To Planning Staff and commission:

EZSTOP Drive Through

Picture highlighting proximity of graves in the cemetery to the drive through

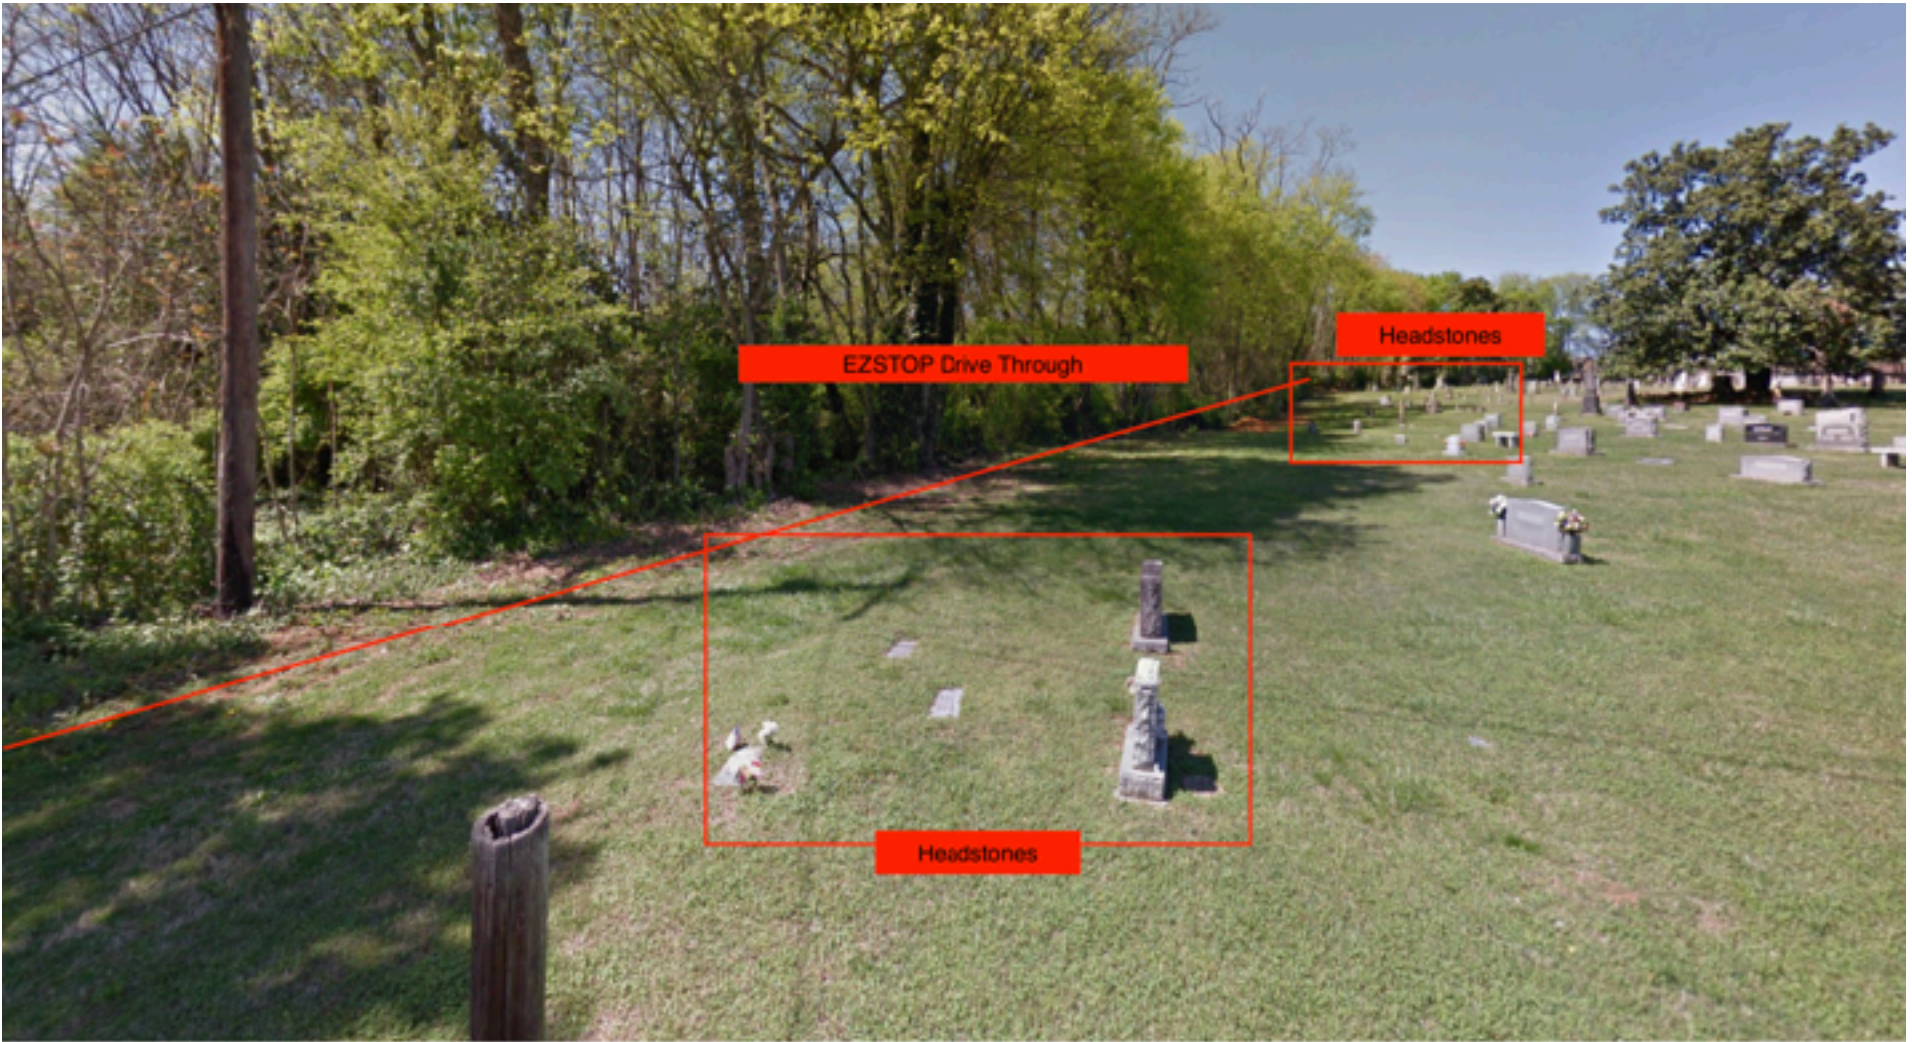
This minimum barrier will afford no protections for our neighborhood against noise, fumes, and vibrations associated with a drive through. As well as the fumes and noise of idling cars waiting in line to order.

According to the USDA Guide of Using agroforestry to buffer noise, to achieve any effective noise reduction the noise buffer must completely block the line of sight. If any light can be seen through the buffer, it is providing no appreciable noise reduction. When only trees and shrubs are used for the buffer, this means the planting must be at least 100 feet wide with evergreen species for year around reduction. Even with wide and dense vegetative buffers noise reduction above 3 to 5 dBA is not likely.

To achieve a 10 dBA reduction (one half the noise level) either a very wide dense tree planting or including a solid barrier is necessary. Solid barriers can be either an earthen berm or a solid wall or fence. If a berm is utilized trees and shrubs should be planted on top and near the recipient. Planting on top of the berm creates a relative increase in height of the trees with respect to the recipient. Solid barriers also reflect sound back toward the source. If this is an issue, a row of shrubs can be planted near the solid barrier on the source side. If a solid wall is constructed the least effective location is within the tree planting and the most effective location is near the source. The buffer should extend in either direction at least four times the distance between the recipient and the buffer.

If the Hazardous impact of light pollution, noise pollution, and toxic fumes cannot be mitigated by a single minimum landscaping, this plans applicant must alter the plan to create an effective and meaningful barrier or the commission should deny the use of a drive through on this property.
